UNITED STATES PATENT AND TRADEMARK OFFICE

Office Action Summary

10/671,629

KIM ET AL.

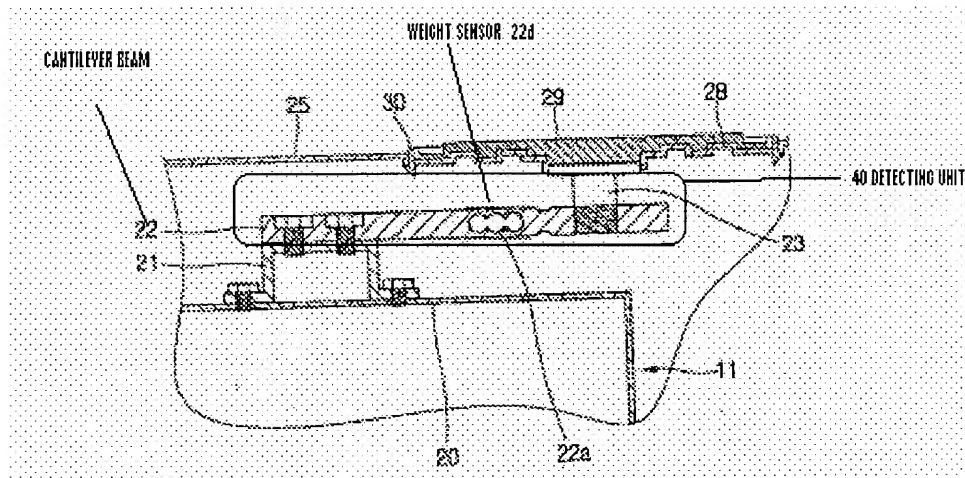
The examiner realizes that Applicant may be his or her own lexicographer as long as the meaning assigned to the term is not repugnant to the term's well known usage. In re Hill, 161 F.2d 367, 73 USPQ 482 (CCPA 1947). However, in this case, Applicant use of the term "sensor" in the claims is repugnant to the standard use of the term in the art. Applicant's weight sensor, in the specification and in Figure 3, is actually a cantilever beam (22). But, the sensing element (22d) is actually the "sensor" because it senses and detects a weight according to a force applied to a free end of the cantilever beam. A "sensor" is used in the art is an electronic component that detects weight. Thus, a "sensor" is not a cantilever beam or plate such as beam 22 in the specification.

Therefore, the Applicant must change in the specification and in the claims the term "weight sensor 22" to "a cantilever beam 22". Further, for clarification, the Examiner has reproduced figure 3 of the application to clarify the examiner's interpretation of the "detecting unit 40", the cantilever beam 22" and "the weight sensor 22d".

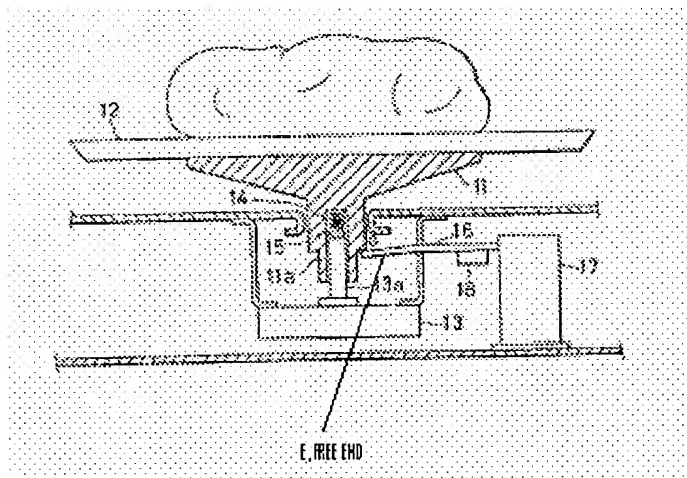
6. Claims 1-2, 6, 8-13, 17-18, 20 and 40 are rejected under 35 U.S.C. 102(b) as being anticipated by Hisaya (JP59215519A). Hisaya discloses cooking utensil comprising a weight detecting unit (16+18) comprising a weight sensor (18), said weight detecting unit supported at an end thereof, and detecting a weight according to a force applied to a free end (E, figure below) thereof; and a support unit (17) to support the weight detecting unit (16+18).

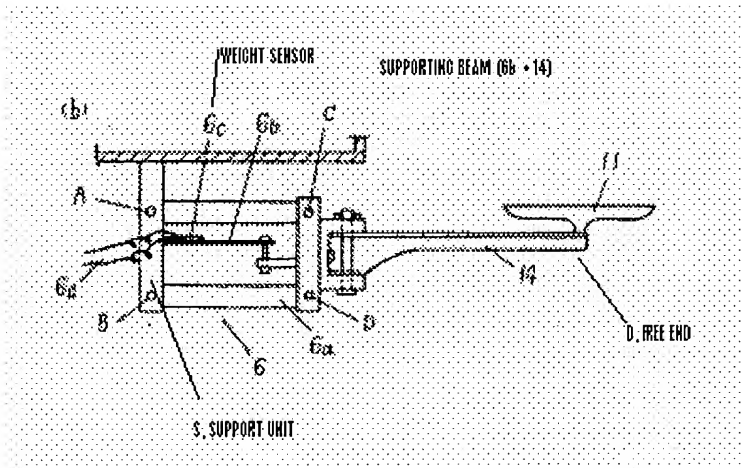
7. Claims 1-2, 9-13 and 20 are rejected under 35 U.S.C. 102(b) as being anticipated by Masaaki (JP57155035A). Masaaki discloses a microwave heater comprising a weight detecting unit (6) comprising a weight sensor (6C), said weight detecting unit (6) supported at an end thereof, and detecting a weight according to a force applied to a free end (D, figure below) thereof; and a support unit (S) to support the weight detecting unit.
